# Addendum Number 01

To Drawings and Specifications dated March 10, 2024

**2024 Watkins & Rowe MS and Cy Park HS Renovations**  
**Cypress Fairbanks Independent School District**  
**CFISD Proposal Number: 24-02-5753-R-RFP**

PBK Project No's.: 240058/240059

04 1ST LEVEL - DEMO CEILING PLAN - AREA F  
 1/8" = 1'-0"

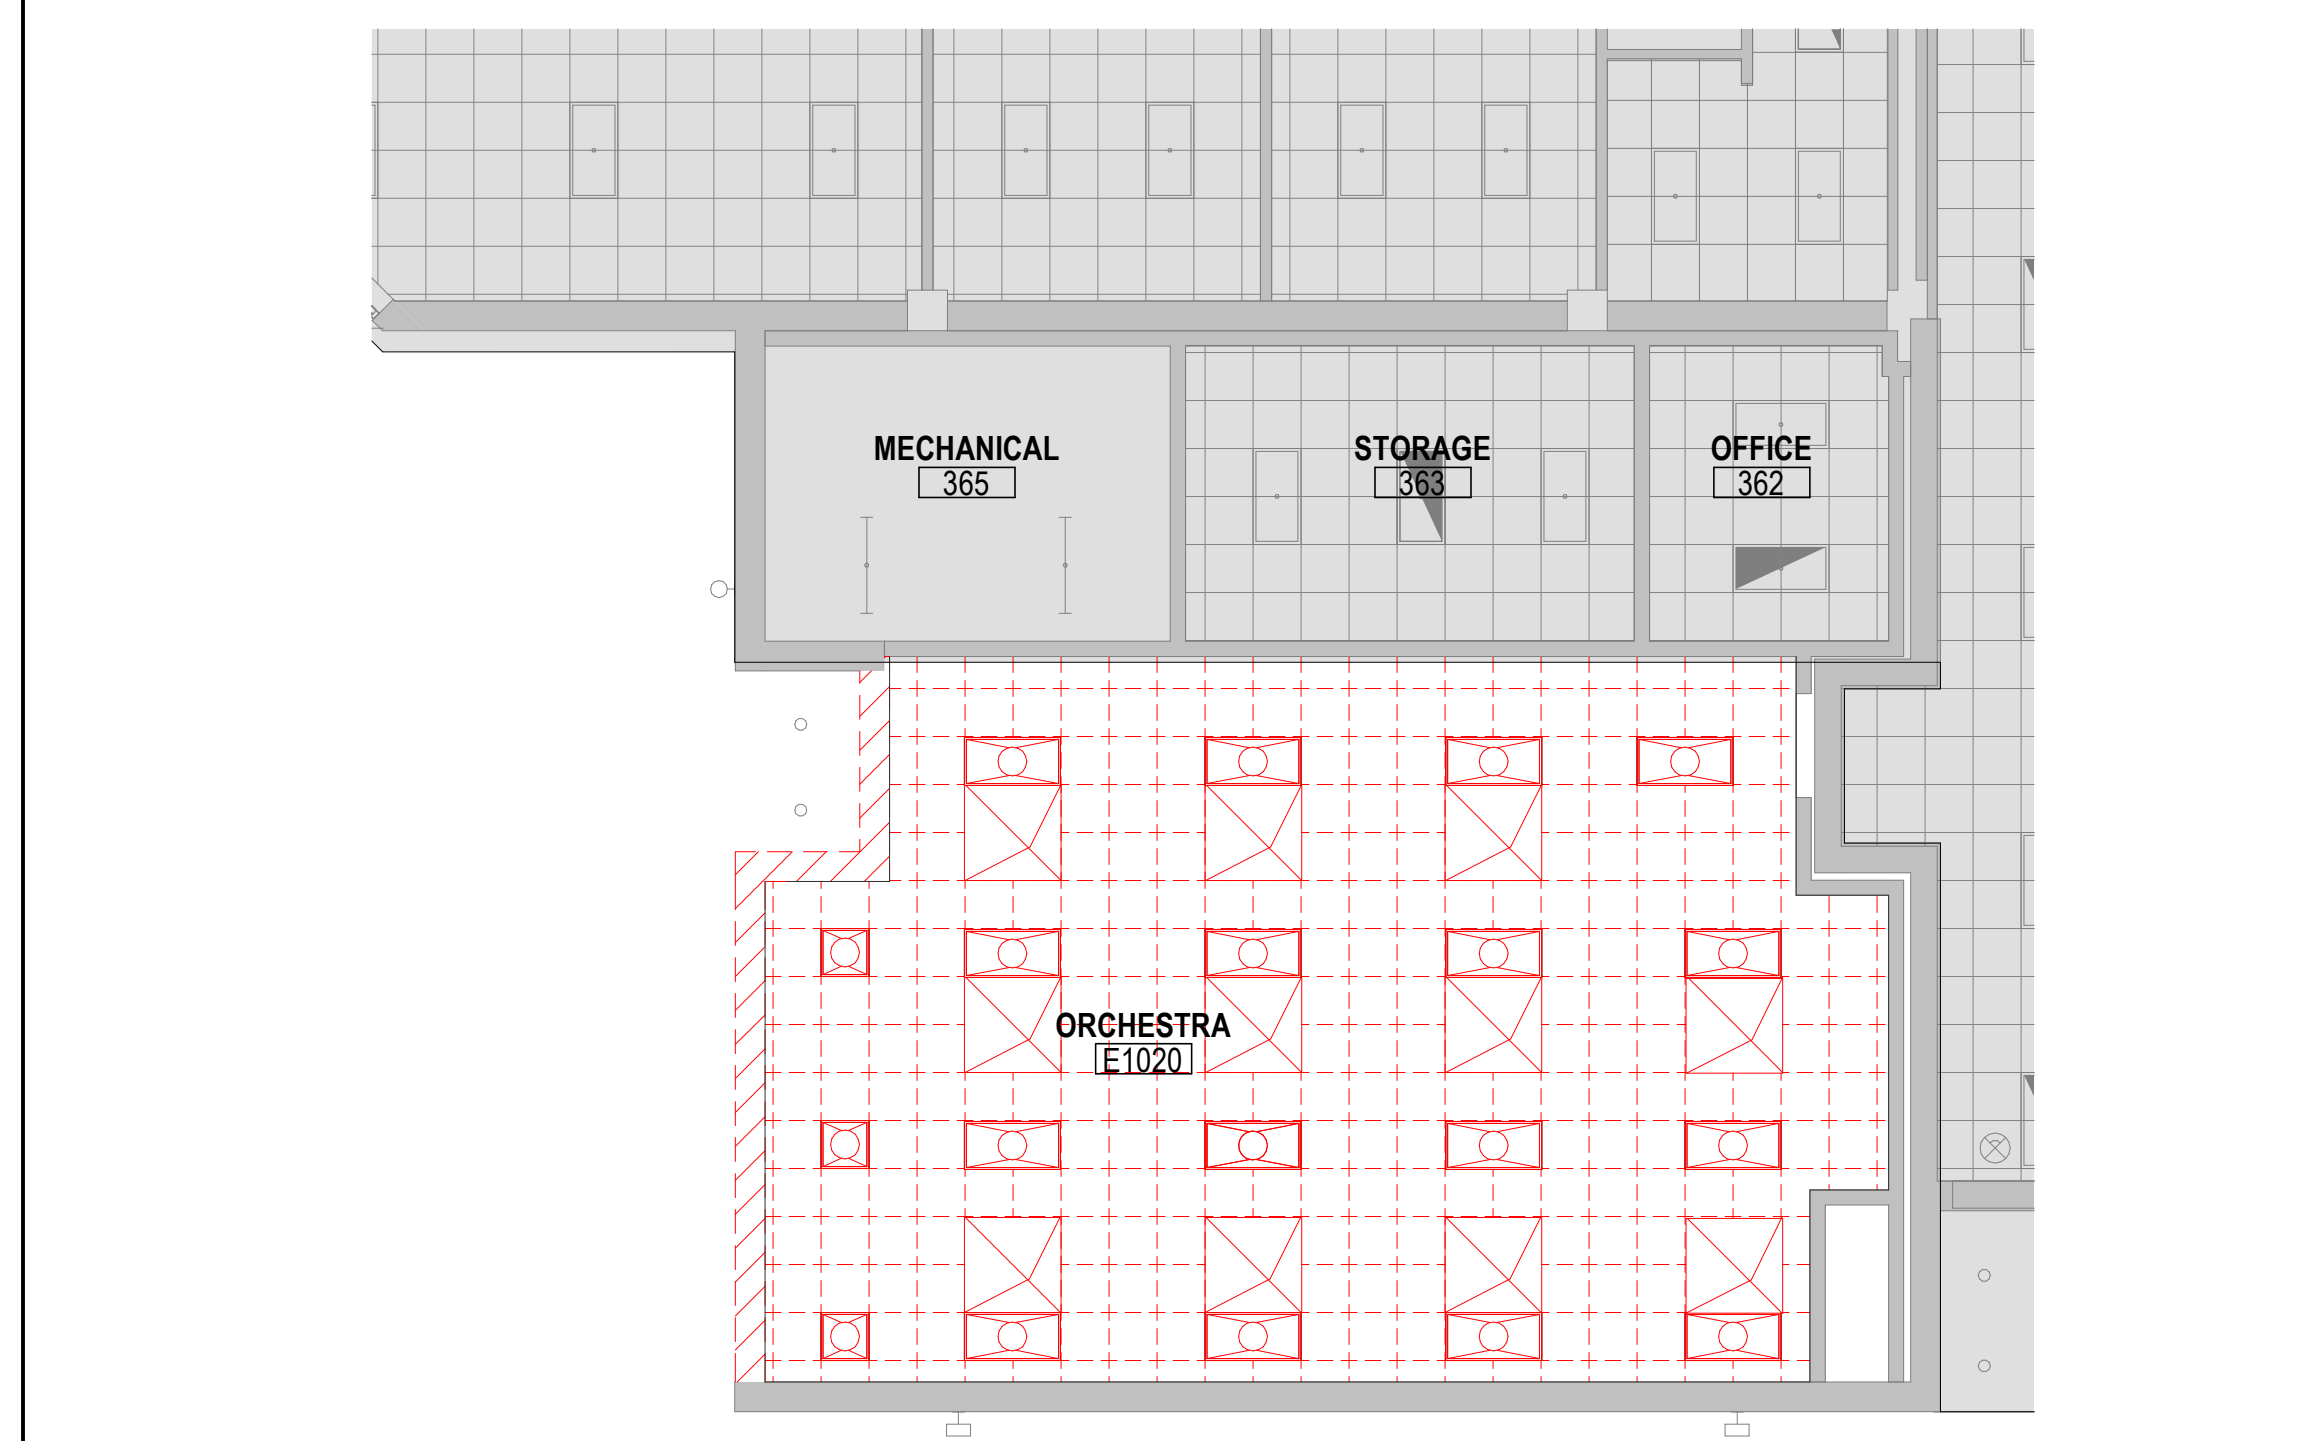
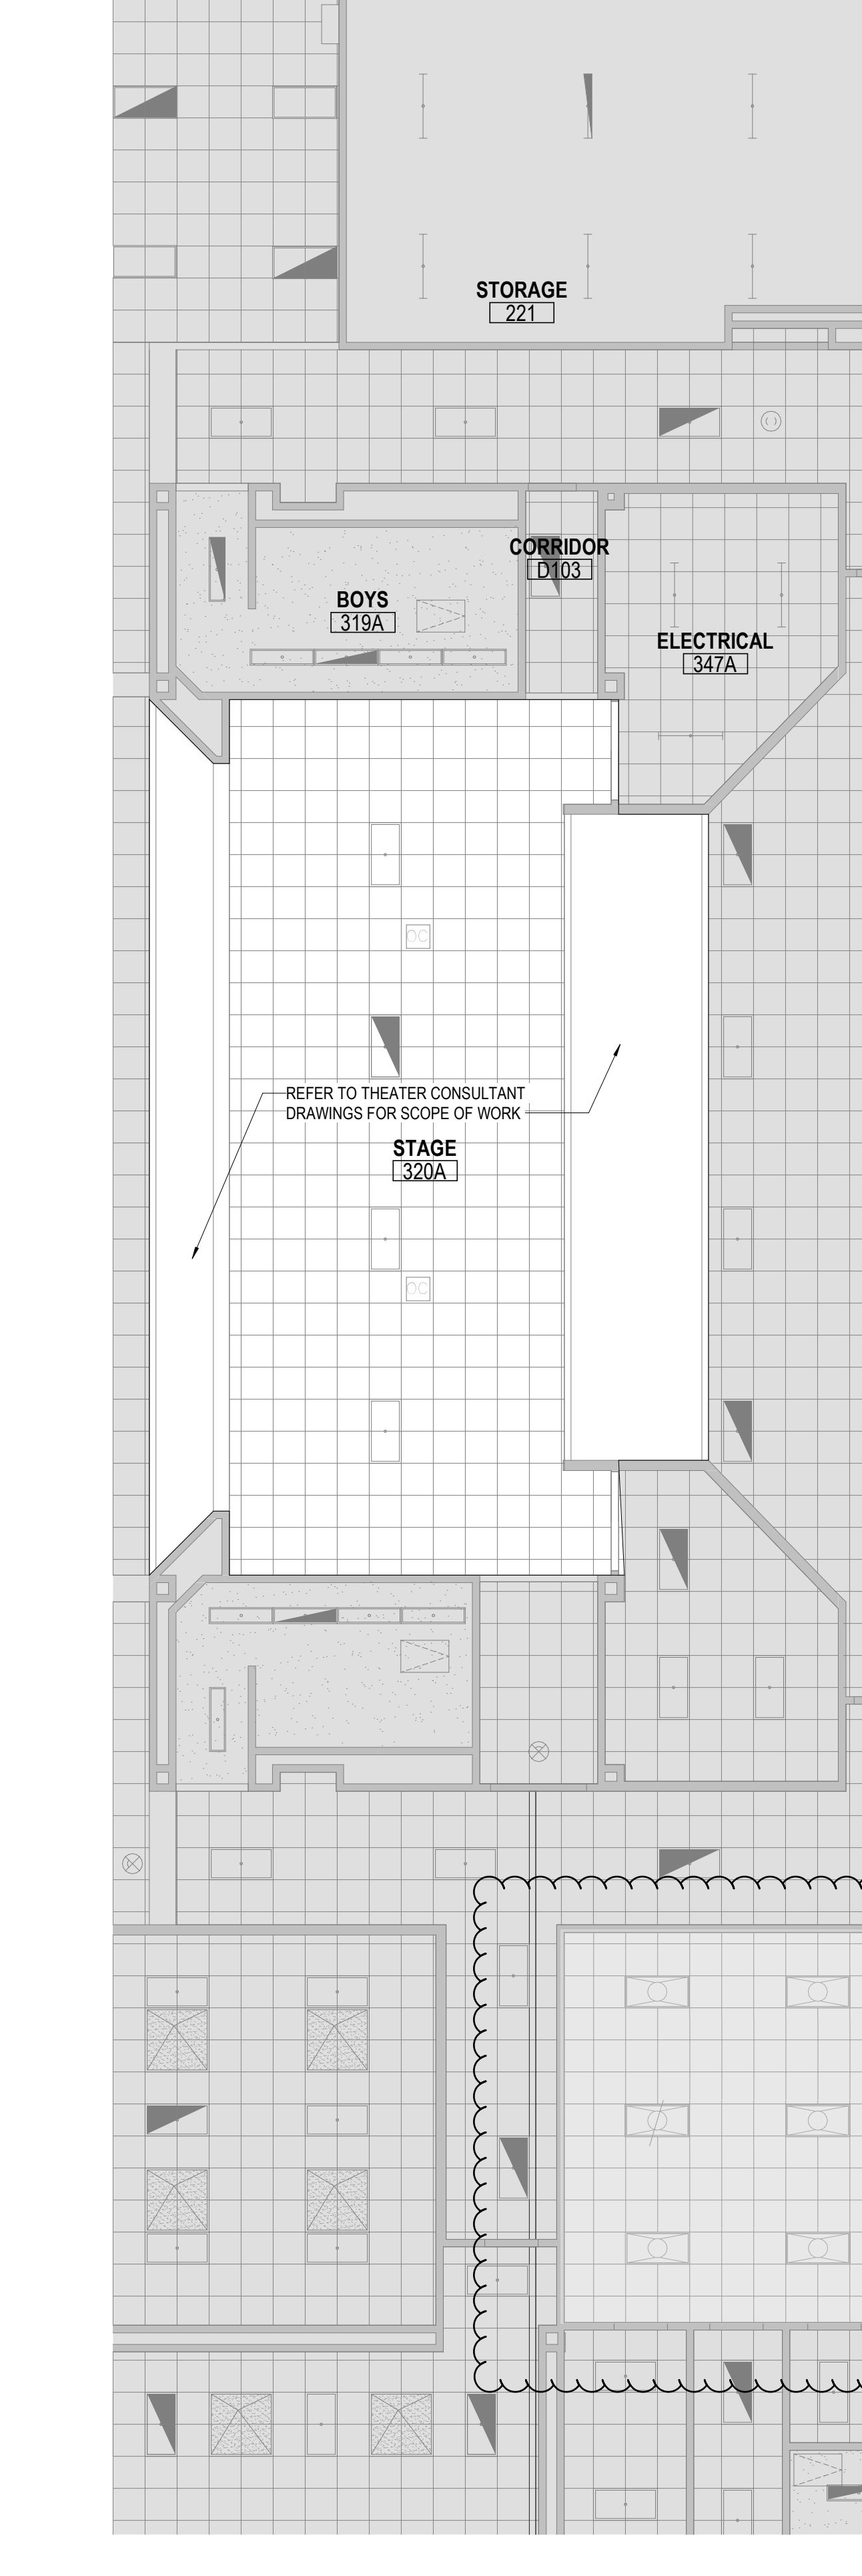
- A. Reception grid changed from demo tiles only to demo tiles and grid.
  - B. Areas not in contract were updated in detail 4.
- Item No. 14** Sheet A-101D – 1ST FLOOR PLAN & SCHEDULES – AREA D
